Technical Service Bulletin

NUMBER: 24-17-99

Vibration Or Noise From HVAC Blower Motor

2000 (PL) Neon

FIGURE 2

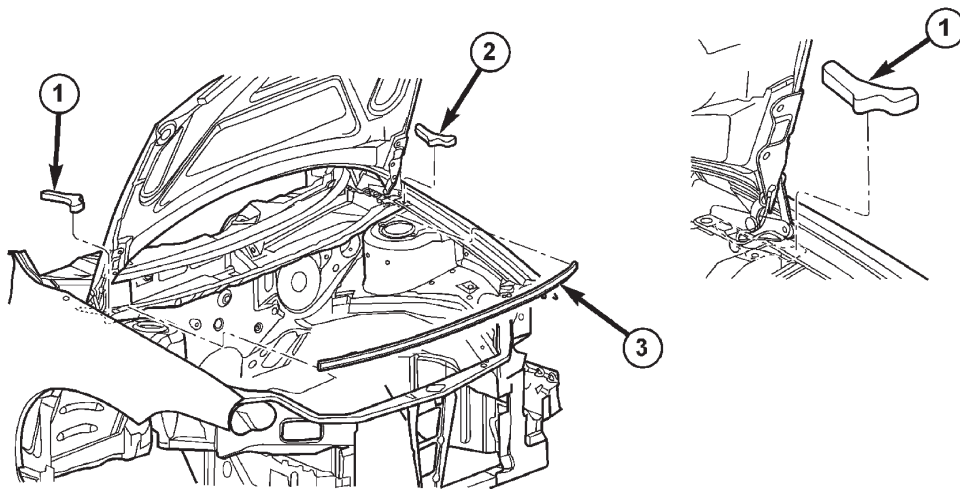
1-	LEFT COWL PLENUM OPENING
2-	LEFT COWL PLENUM SCREEN
3-	RIGHT COWL PLENUM SCREEN
4-	RIGHT COWL PLENUM OPENING

- 10. Install the new cowl plenum screens into the holes in the cowl plenum reinforcement as shown in Figure 2.
- 11. Install the cowl top screen assembly.
- 12. Install the new fender to hood hinge seals.
- 13. Install the cowl plenum to hood weatherstrip.
- 14. Install the wiper arm assemblies.

FIGURE 1

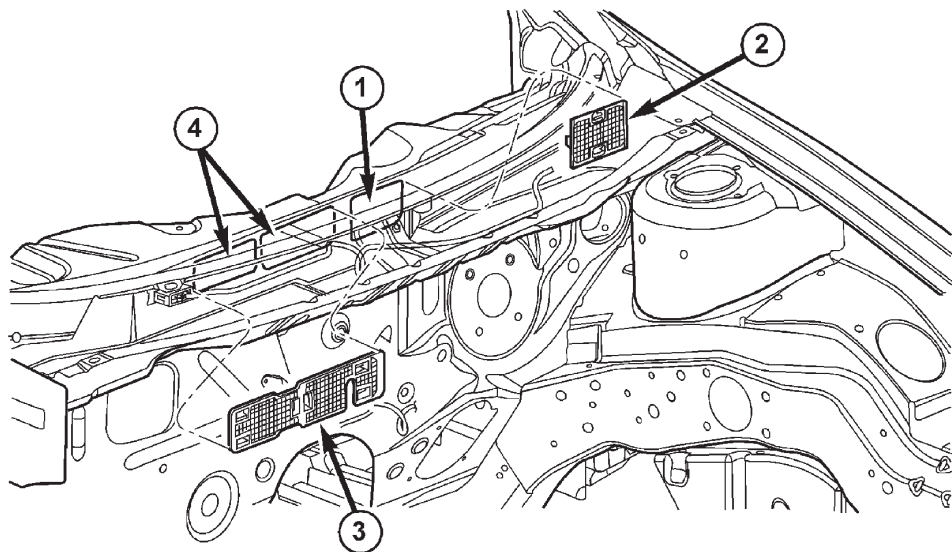
1. Remove the HVAC blower motor following the procedure in the 2000 Neon Service Manual (Publication No. 81-270-0025) beginning on page 24-21.
2. Remove any debris which is found in the HVAC blower motor.
3. Remove both wiper arm assemblies following the procedure in the 2000 Neon Service Manual (Publication No. 81-270-0025) beginning on page 8K-5.
4. Remove the cowl plenum to hood weatherstrip (Figure 1).
5. Remove the left and right fender to hood hinge seals (Figure 1).
6. Remove the cowl top screen assembly following the procedure in the 2000 Neon Service Manual (Publication No. 81-270-0025) beginning on page 23-27.
7. Remove any debris found in the cowl plenum.
8. Install the HVAC blower motor following the procedure in the 2000 Neon Service Manual (Publication No. 81-270-0025) beginning on page 24-21.
9. Operate the HVAC blower motor to verify that all debris has been removed.

1-	FENDER TO HOOD HINGE SEAL
2-	FENDER TO HOOD HINGE SEAL
3-	COWL PLENUM TO HOOD WEATHERSTRIP
